18th February 2021

Re: Request for Advice – Sirius Developmentm 2-60 Cumberland Street, The Rocks (Landscape)
Council Ref: R/2019/20/A
File No: 2020/564775
Ref: SSD-10384

Further to the City of Sydney Request for Advice – dated 17th December 2020, we provide the following response in relation to landscape specific items.

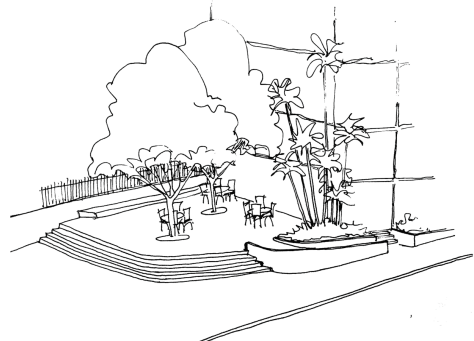
6. Public Domain

Details of paving selections and finishes is to be addressed as part of detailed design of the Public Domain and subject to further development, consultation, review and approval by PMNSW.

A detailed design of the public domain (including a plan showing the type and location of bins, bollards, seating and the like to be installed) shall be submitted to PMNSW for approval prior to the issue of final LOC or CC as per the condition outlined in PMNSW Response to Environmental Impact Statement – _SSD 10384.

Refer to the site civil and stormwater design for details on footpath gradients and stormwater capture.

Design Review Panel Comments - Green Roof Maintenance

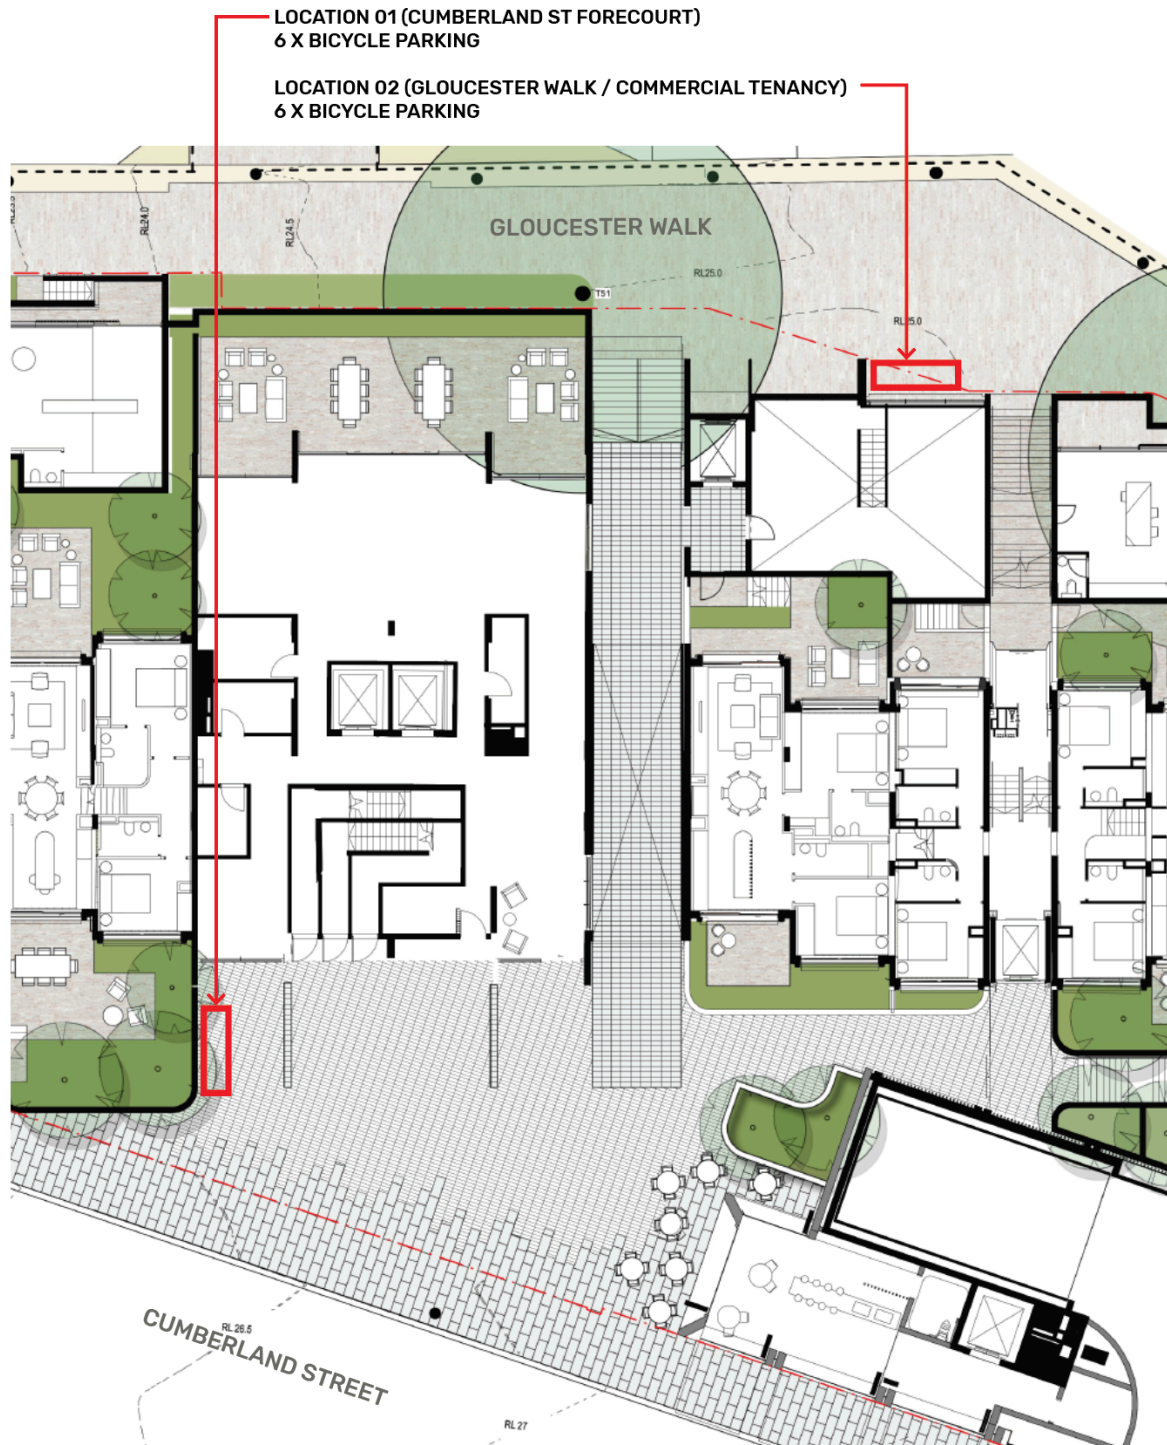
Comments raised in the Design Panel comments 3.15 (1st Review) and 3.8 (2nd Review) regarding maintenance of the Green Roofs, access and methodology have been addressed (*Refer Appendix D – Rooftop Access and Maintenance*).

The green roofs are maintained via a series of permanent ladders and static lines that are accessed from manholes located within the central cores. All private rooftop gardens are accessed for maintenance from within the terrace via static line connection.

A detailed Green Roof maintenance Access and Methodology report will be prepared and submitted to City of Sydney for approval prior to the issue of final LOC or CC.

Precinct 2 The Rocks & Millers Point

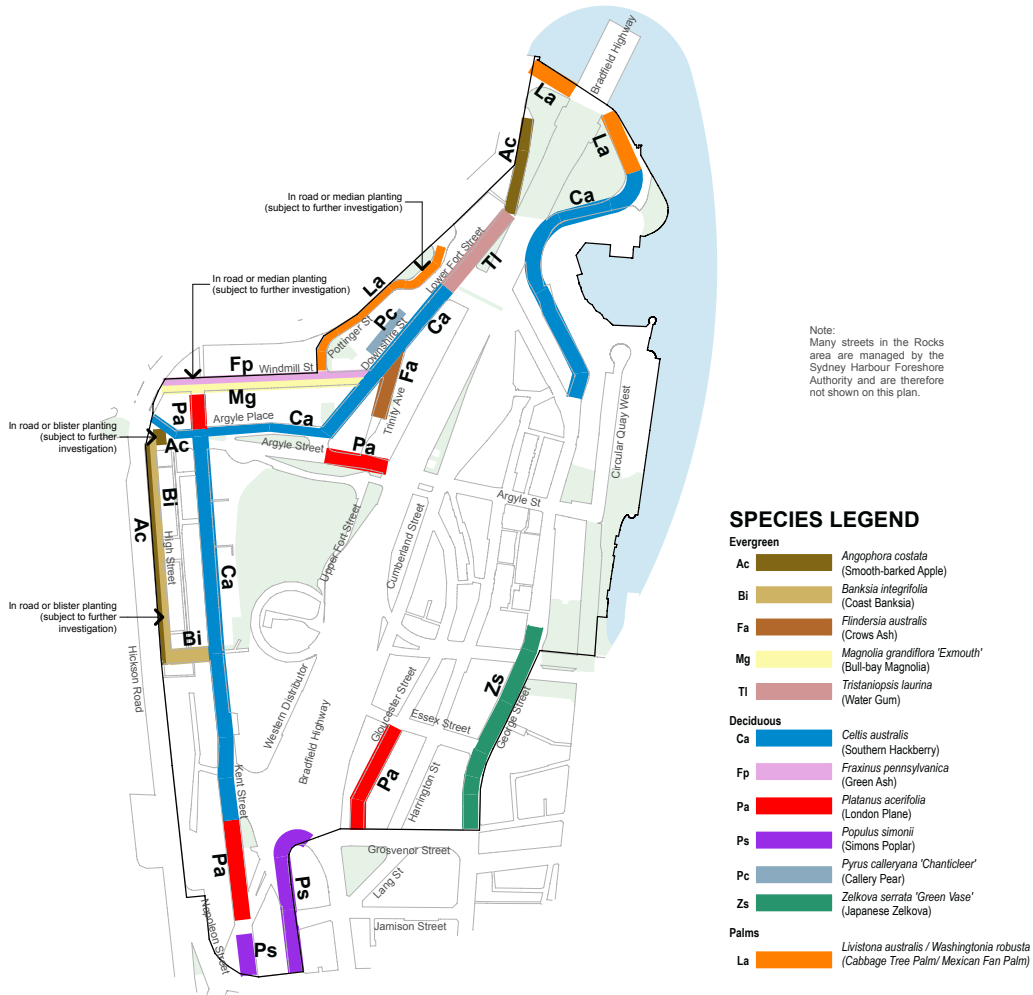
It is understood that Cumberland Street forms a view corridor to Sydney Harbour Bridge and street trees are not to be planted to preserve the view. The City of Sydney Street Trees Masterplan supports this understanding as no street trees are identified along Cumberland Street (*Refer Appendix C – Extract of CofS Street Trees Masterplan*). Additionally, PMNSW have not requested street trees along Cumberland St as part of the proposed public domain works.
